SKILLING, HELLE, CHRISTIANSEN, ROBERTSON — Structural & Civil Engineers

PROJECT THE WORLD TRADE CENTER | TITLE REVISION AFTER FABRICATION DETAIL 904 | DATE 8-15-68

19-A-904

Det. A (typ.)

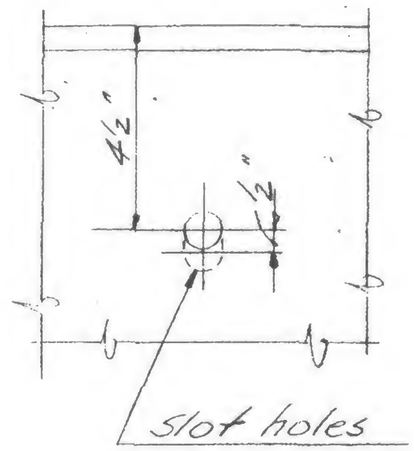
deleted from Set before 1st issue - change to SHOP DWG by engineer & will appear this way

Section Y-Y on SA-6 schedules ¾"ϕ holes at 5" from top flange

Deleted (see sheet)
